METRO HISTORIC ZONING COMMISSION

HISTORICAL COMMISSION PERMIT - 2020055412

Purpose: Construct DADU. See HCP 2020055397 for addition permit.

ADDITION, RENOVATION, & DADU AT:
2806 OAKLAND AVE.
NASHVILLE, TN 37212

SITE PLAN
01

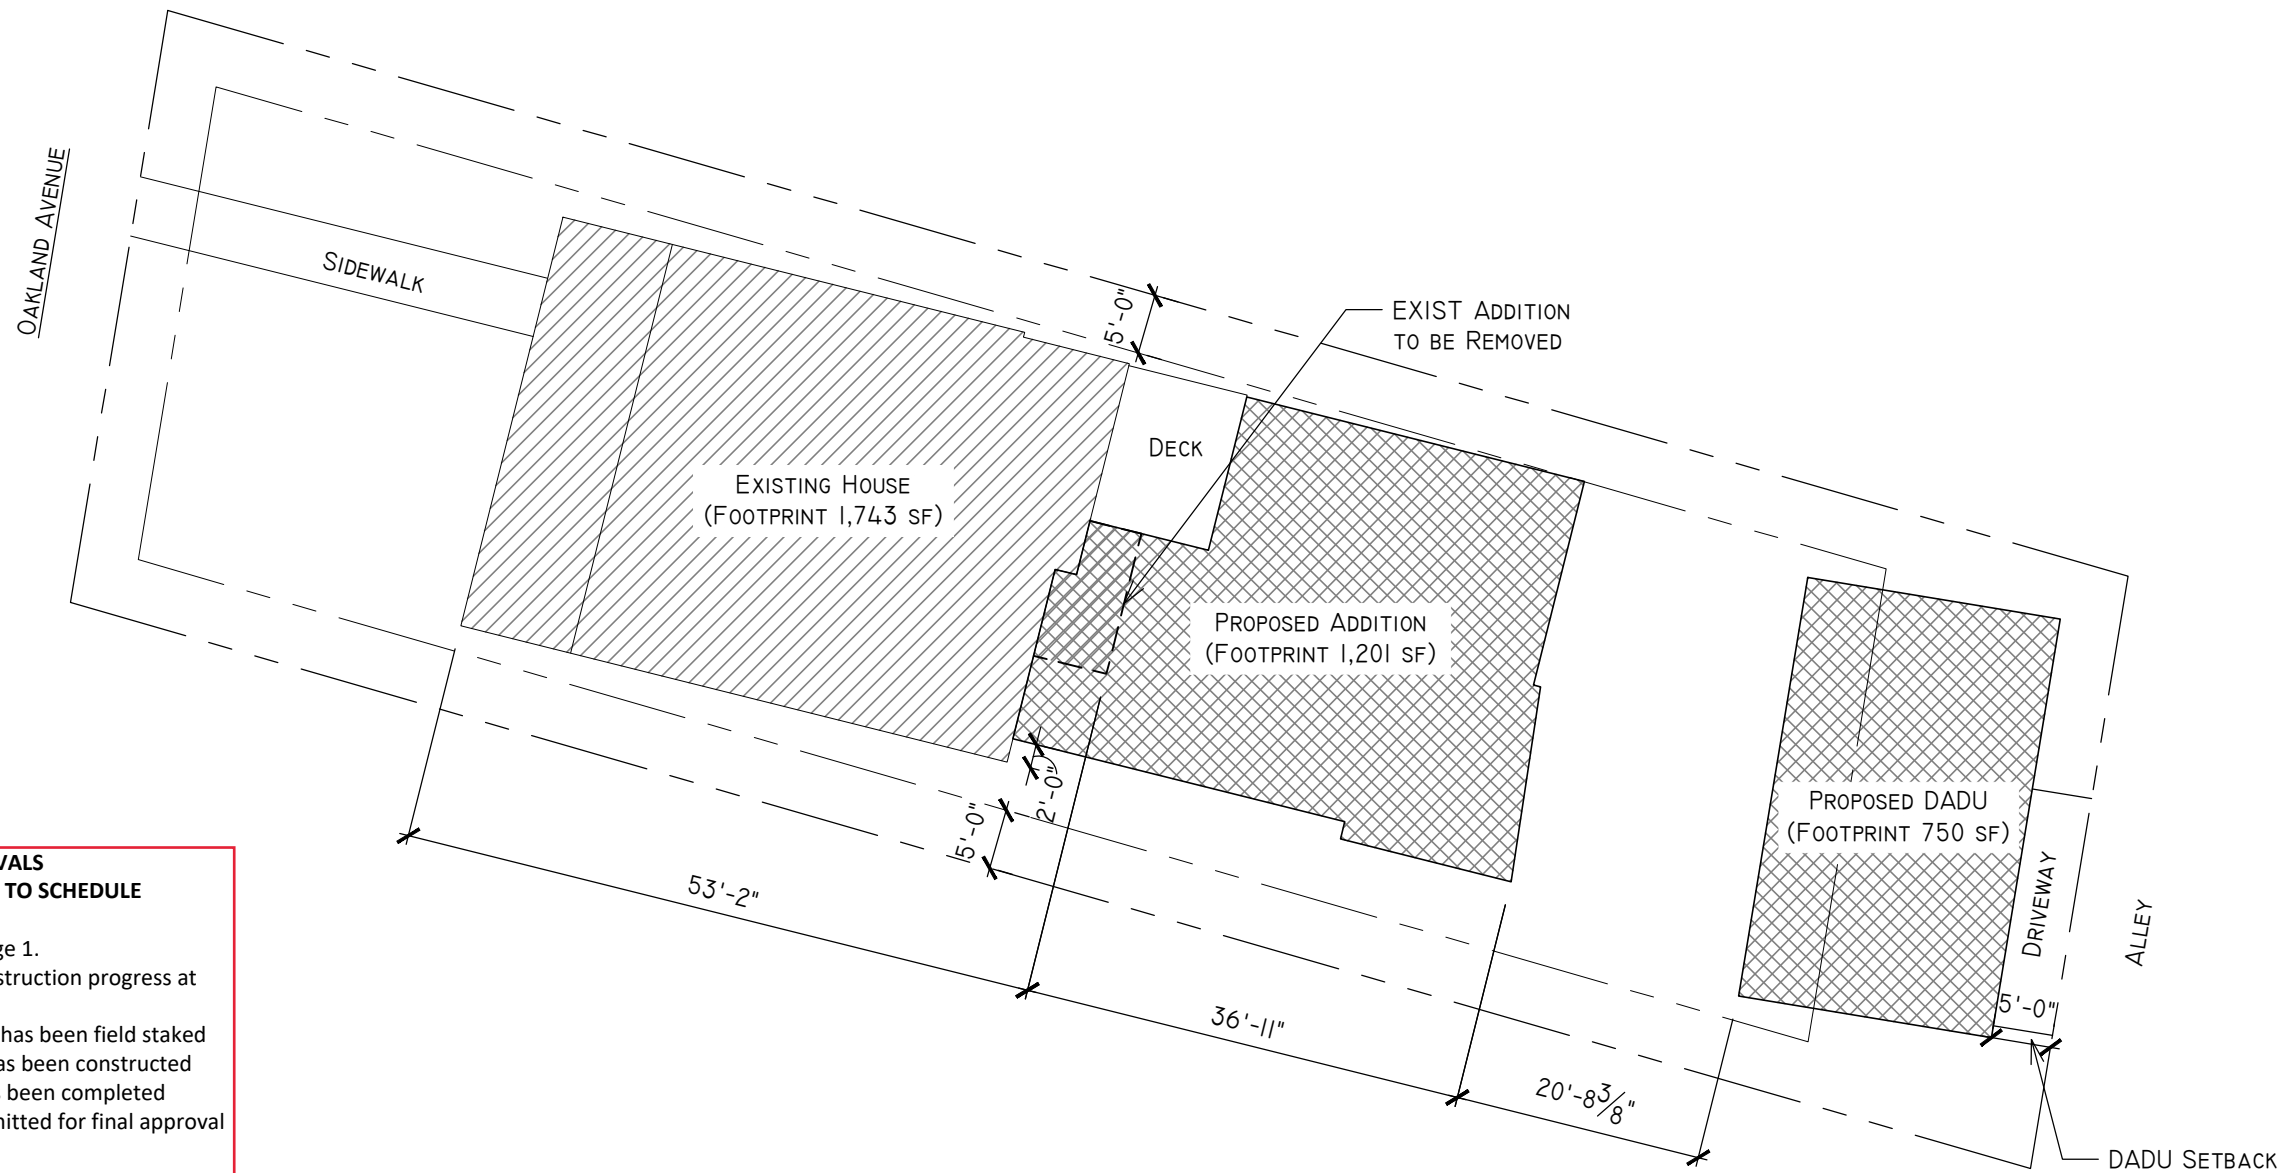
1. Structure to be constructed in accordance with attached scaled site plan and elevations. Any deviation from the approved plans could result in **changes being reversed** to reflect the approved drawings. Any alterations, whether or not approved by other Metro Departments, must be communicated to MHHC for a revision of the permit prior to construction or material purchase.

3. Exterior finish materials shall be trim grade (smooth and square). Stud wall lumber or embossed wood grain is not appropriate.
4. Windows shall be single-light or fully simulated, divided light sashes. Muntins are to be factory installed with an exterior muntin, interior muntin and a spacer bar within the double paned-glass. Snap-in or between the glass muntins are never appropriate. Double and triple windows shall have 4" to 6" mullions between.

5. Four (4) inch (nominal) wood casings are required around doors, windows and vents within clapboard walls. Windows on clapboard structures shall not have brick-mold.

9. HVAC/Mechanical/Utility vents, pipes, lines, and all associated components, condensers or boxes shall be located behind the midpoint of the structure on a non-street facade.

10. For non-masonry buildings, siding and trim shall be wood or smooth-faced, cement-fiberboard (e.g.: Hardiplank). If siding exposure is not matched to that of the existing house, then it shall have a maximum reveal of five (5) inches.

11. For non-masonry buildings, 4 inches (nominal) wood corner-boards are required at the face of each exposed corner.

EXTERIOR ELEVATIONS

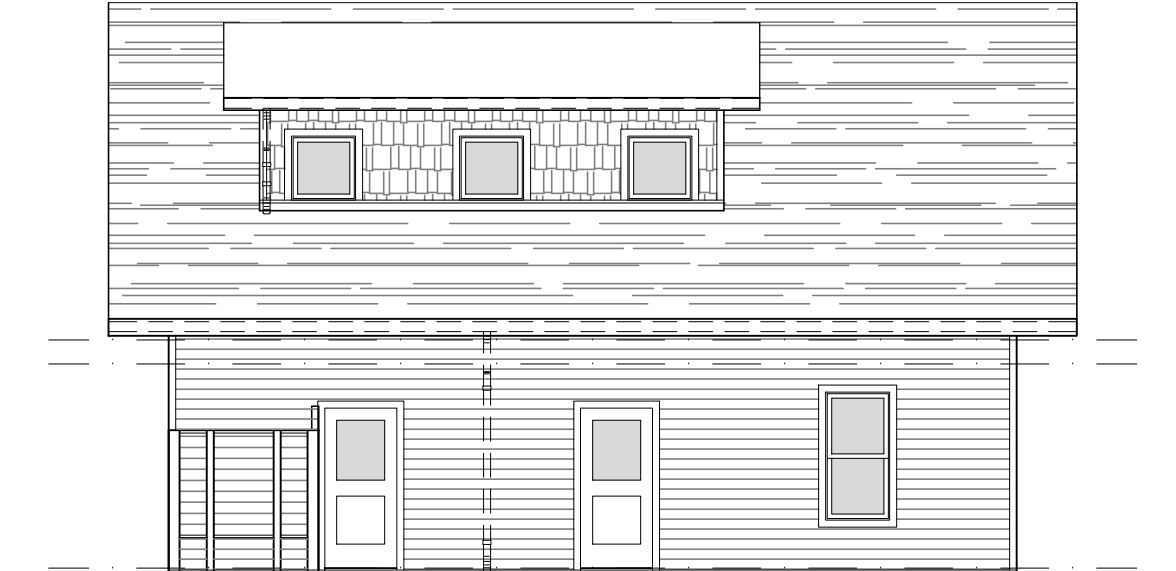
- Structure to be constructed in accordance with attached scaled site plan and elevations. Any deviation from the approved plans could result in **changes being reversed** to reflect the approved drawings. Any alterations, whether or not approved by other Metro Departments, must be communicated to MHZC for a revision of the permit prior to construction or material purchase.

- Exterior finish materials shall be trim grade (smooth and square). Stud wall lumber or embossed wood grain is not appropriate.
- Windows shall be single-light or fully simulated, divided light sashes. Muntins are to be factory installed with an exterior muntin, interior muntin and a spacer bar within the double paned-glass. Snap-in or between the glass muntins are never appropriate. Double and triple windows shall have 4" to 6" mullions between.

- Four (4) inch (nominal) wood casings are required around doors, windows and vents within clapboard walls. Windows on clapboard structures shall not have brick-mold.

- HVAC/Mechanical/Utility vents, pipes, lines, and all associated components, condensers or boxes shall be located behind the midpoint of the structure on a non-street facade.

- For non-masonry buildings, siding and trim shall be wood or smooth-faced, cement-fiberboard (e.g.: Hardiplank). If siding exposure is not matched to that of the existing house, then it shall have a maximum reveal of five (5) inches.

- For non-masonry buildings, 4 inches (nominal) wood corner-boards are required at the face of each exposed corner.
